TVA-SQN-TS-05-03

SEQUOYAH NUCLEAR PLANT (SQN) - UNITS 1 AND 2 - TECHNICAL SPECIFICATIONS (TS) CHANGE 05-03 "REVISION OF ACTIONS AND APPLICABILITY FOR REACTOR TRIP SYSTEM INSTRUMENTATION, TURBINE TRIP"

TENNESSEE VALLEY AUTHORITY (TVA) SEQUOYAH NUCLEAR PLANT (SQN) UNITS 1 AND 2

Proposed Technical Specification Changes (mark-up)

TABLE 3. 3-1 (Continued)

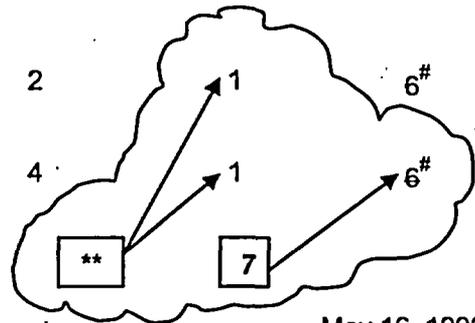
17. Underfrequency-Reactor Coolant Pumps	4-1/bus	2	3	1	6 [#]
18. Turbine Trip					
A. Low Fluid Oil Pressure	3	2	2		
B. Turbine Stop Valve Closure	4	4	4

ACTION 7 - Deleted
Insert 1

ACTION 7 - With the number of OPERABLE channels one less than the Total Number of Channels, STARTUP and/or POWER OPERATION may proceed provided the inoperable channel is placed in the tripped condition within 6 hours or THERMAL POWER is reduced to less than P-9 within 10 hours.

TABLE 3.3-1 (Continued)

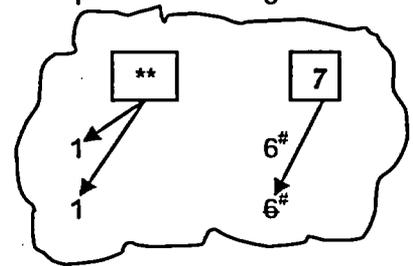
<u>FUNCTIONAL UNIT</u>	<u>TOTAL NO. OF CHANNELS</u>	<u>CHANNELS TO TRIP</u>	<u>MINIMUM CHANNELS OPERABLE</u>	<u>APPLICABLE MODES</u>	<u>ACTION</u>
16. Undervoltage-Reactor Coolant Pumps	4-1/bus	2	3	1	6 [#]
17. Underfrequency-Reactor Coolant Pumps	4-1/bus	2	3	1	6 [#]
18. Turbine Trip					
A. Low Fluid Oil Pressure	3	2	2		
B. Turbine Stop Valve Closure	4	4	4		
19. Safety Injection Input from ESF	2	1	2	1, 2	12
20. Reactor Trip Breakers					
A. Startup and Power Operation	2	1	2	1, 2	12, 15
B. Shutdown	2	1	2	3*, 4* and 5*	16
21. Automatic Trip Logic					
A. Startup and Power Operation	2	1	2	1, 2	12
B. Shutdown	2	1	2	3*, 4* and 5*	16
22. Reactor Trip System Interlocks					
A. Intermediate Range Neutron Flux, P-6	2	1	2	2, and*	8a
B. Power Range Neutron Flux, P-7	4	2	3	1	8b

ACTION 7 - Deleted.

Insert 1
